MARKER LIGHT GUARD PAINT
Prevost vehicles

On the vehicles affected by this bulletin, replace the IMRON painted marker light guards with powder coated marker lights.

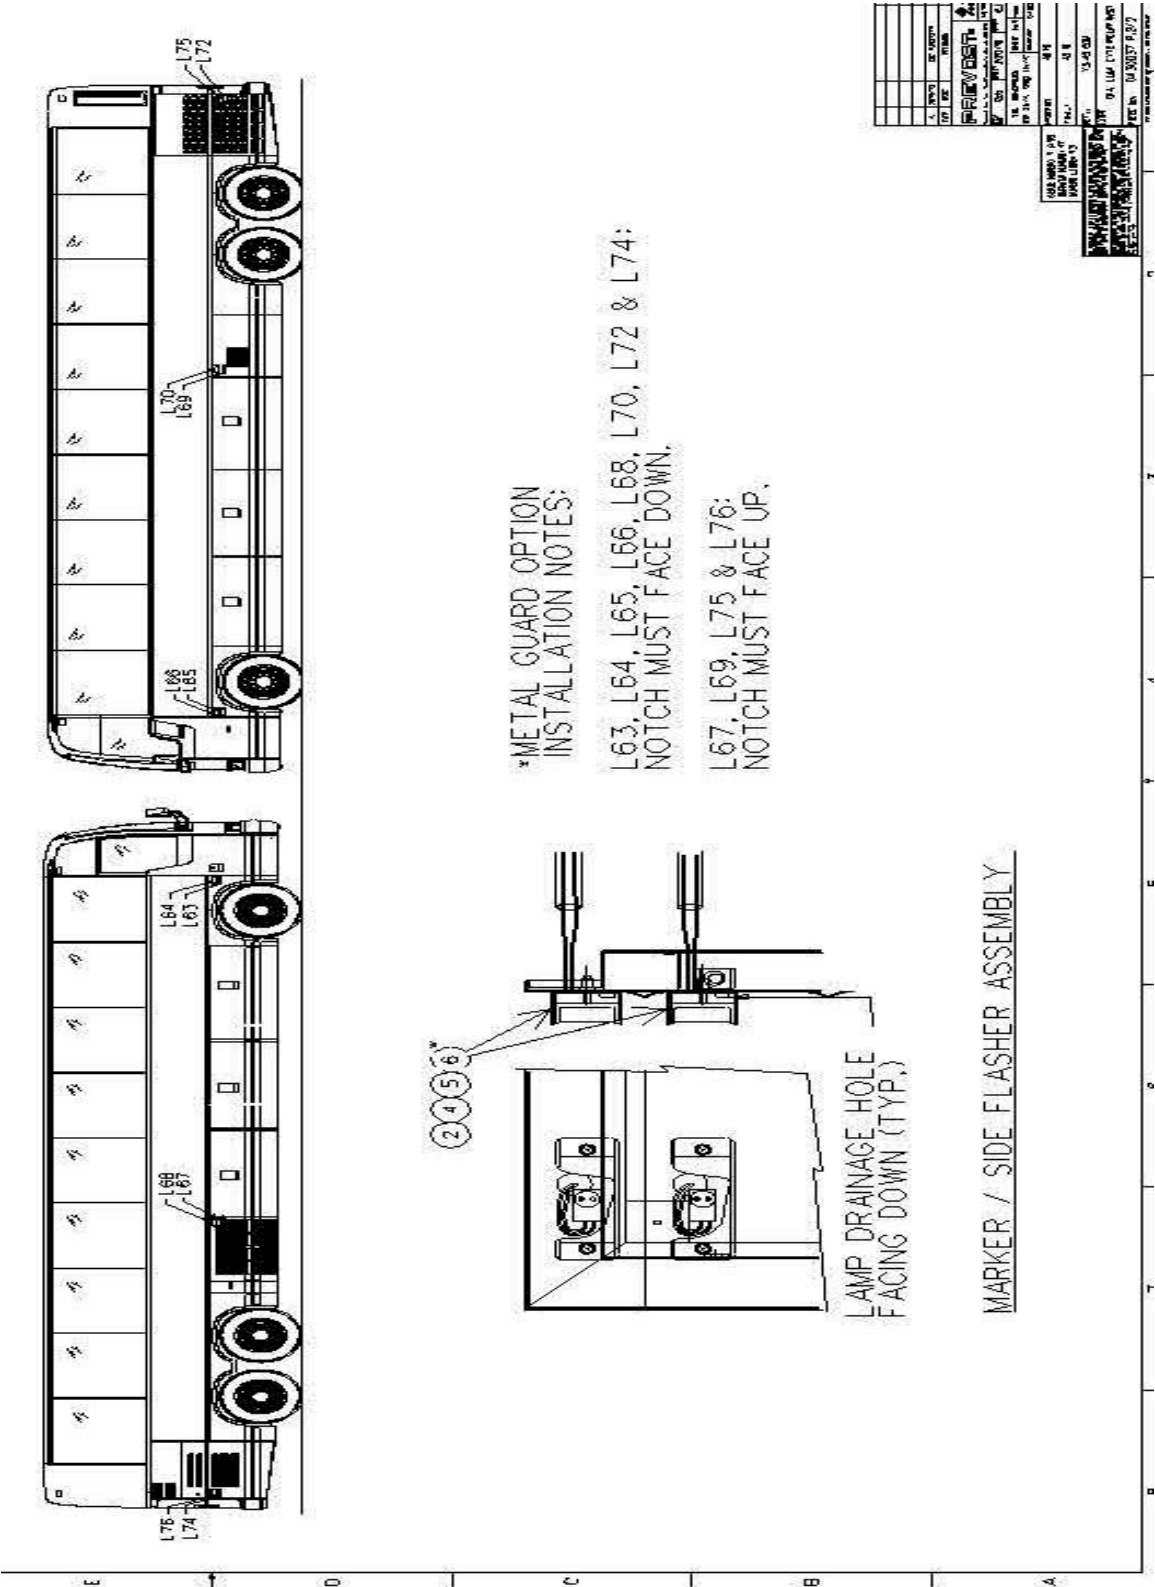
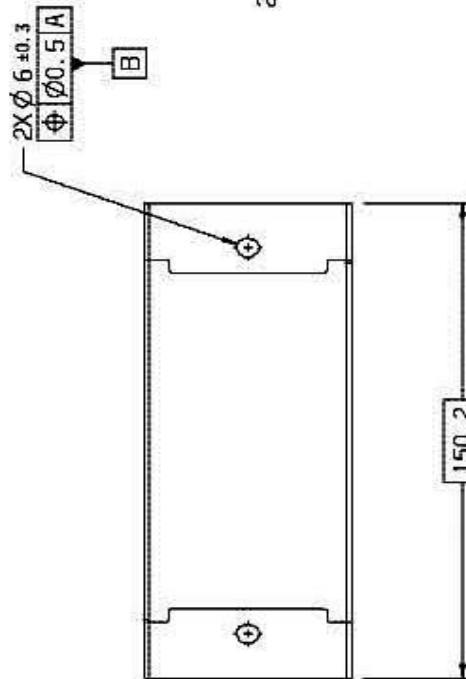
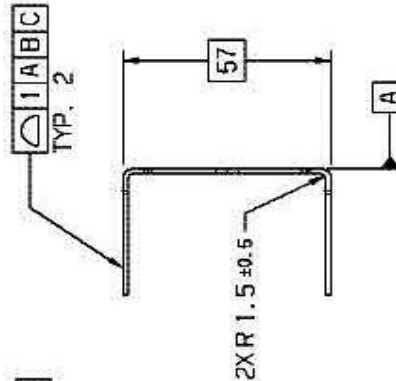
Replace marker light guards by 430696 rev C or higher.
